**AR 22-0001**  
**Plambeck Gardens**  
**23500 SW Boones Ferry Road**

**ARCHITECTURAL REVIEW BOARD**  
**June 8, 2022**

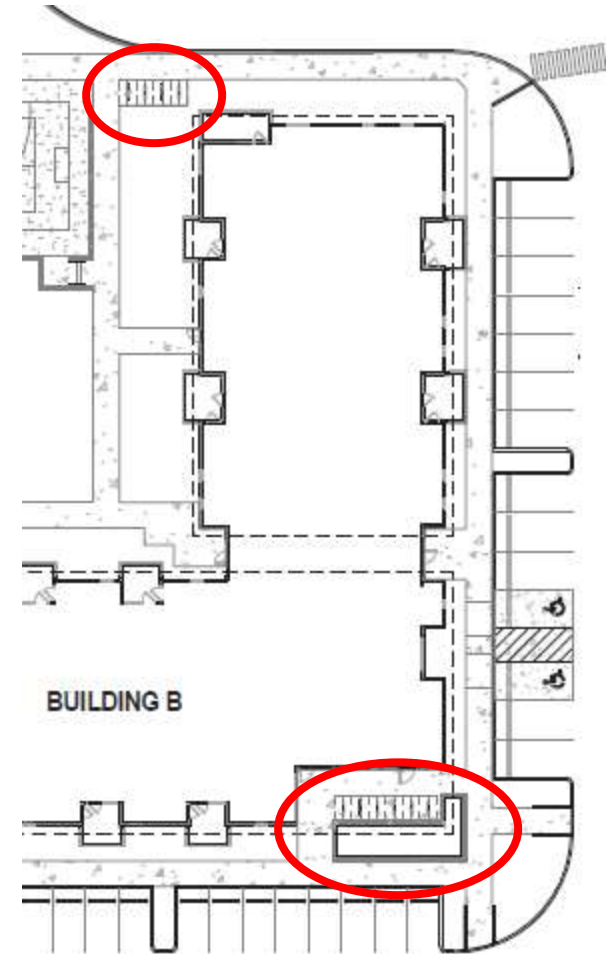
**With conditions, the proposal complies with TDC 73C.250(2):**

- Each bicycle parking space must be at least six feet long and two feet wide, with overhead clearance in covered areas must be at least seven feet; [...]

NW TRASH ENCLOSURE

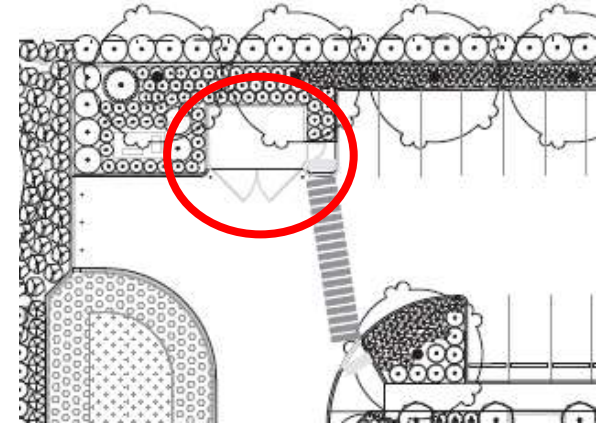
**With conditions, the proposal complies with TDC 73D.070(2):**

- Exterior storage areas must be enclosed by a sight obscuring fence or wall at least 6 feet in height.
- Vertical clearance of 8 feet is required if the storage area is covered.
